MAR401/403 and MAFR401/403 Series

Bonnet Design Change Notification

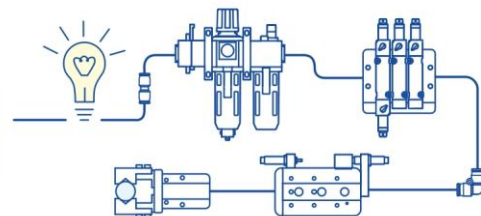
In response to market demand, bonnet provides screw design that can be attached to the machine panel.
